Climate Change and the Catawba-Wataree Basin

CO₂ Emissions Scenarios used in the C-W Water Supply Master Plan

Average Temperature

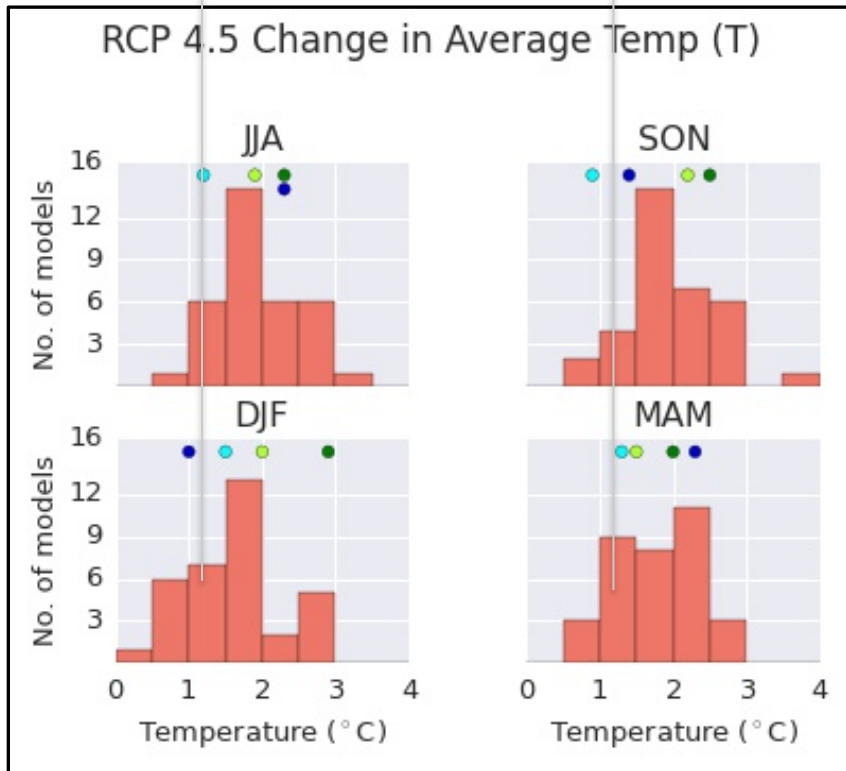
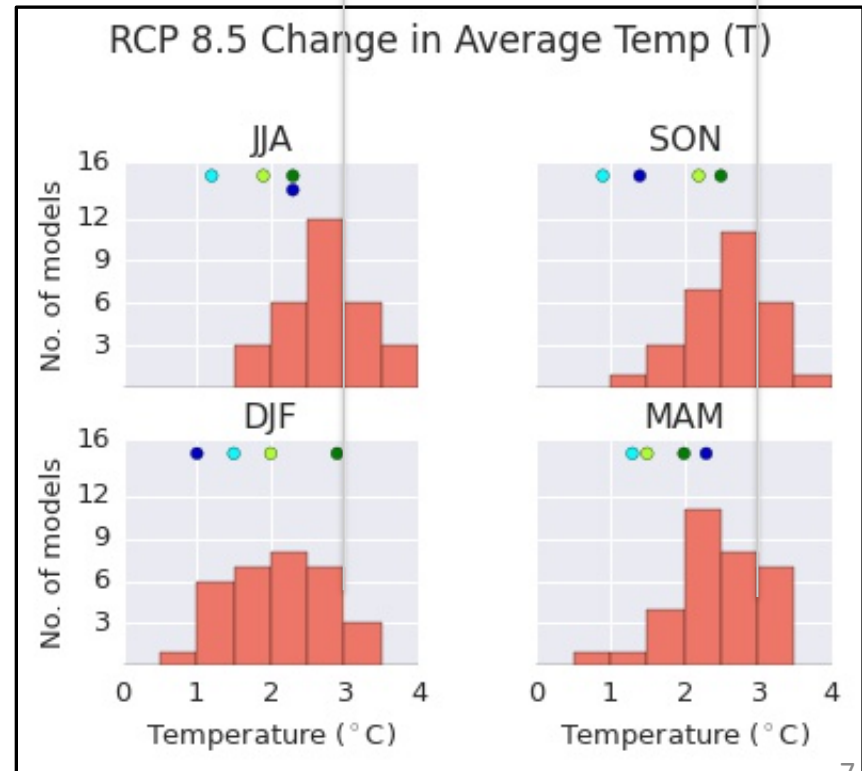
Projected temperature changes from general circulation models show mid-century warming ranging from 1 to 4°C depending on season and climate model. This is commensurate with the 6.5°F (3°C) temperature change shown in the high-end scenario depicted in the Master Plan.

WSMP CC-02: 2.7°F in 2065

WSMP CC-03: 6.5°F in 2065

Precipitation

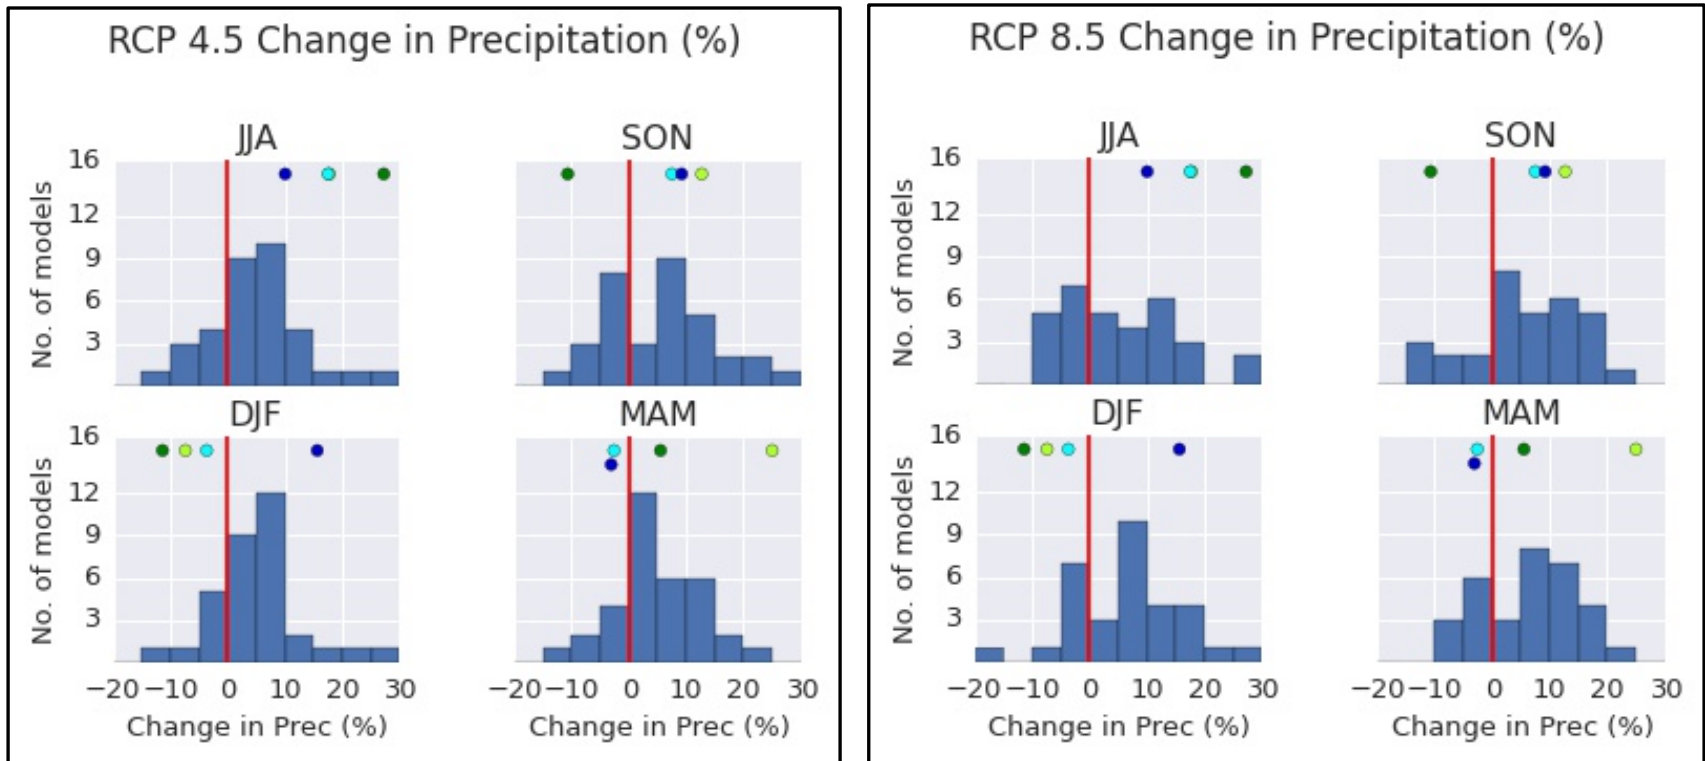
Projected precipitation changes from general circulation models show a wide range (from 20% drier to 30% wetter) depending on season and climate model.

Examination of 100-year historic records and climate model projections (not shown) suggest some evidence for more intense precipitation in recent years and in the future.

HSPF simulations, 2051-2070

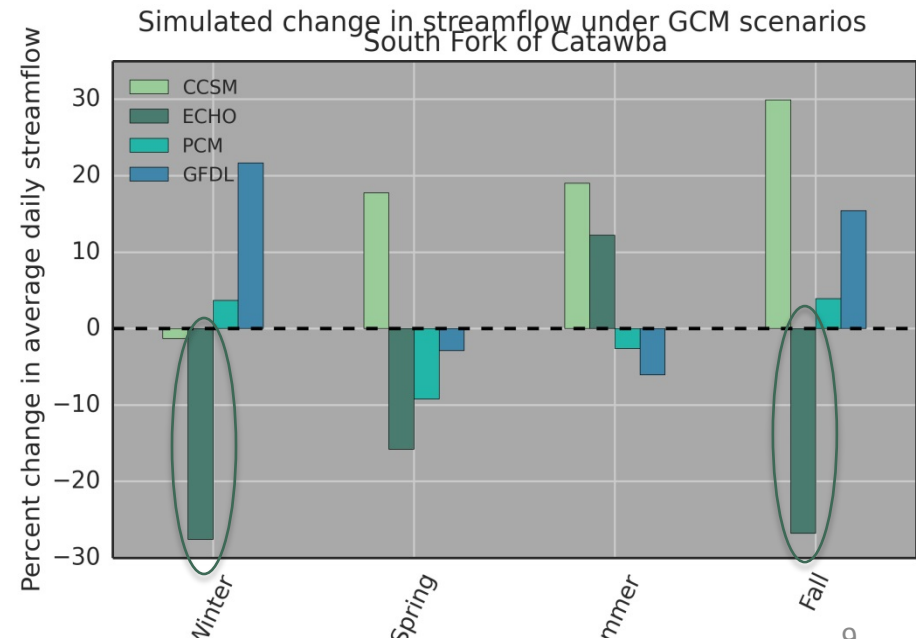
Seasonal streamflow simulated with the Hydrological Simulation Program – FORTRAN model. Output from four climate models provide meteorological inputs for years 2051-2070. Streamflow changes can be specific depending on season and model.
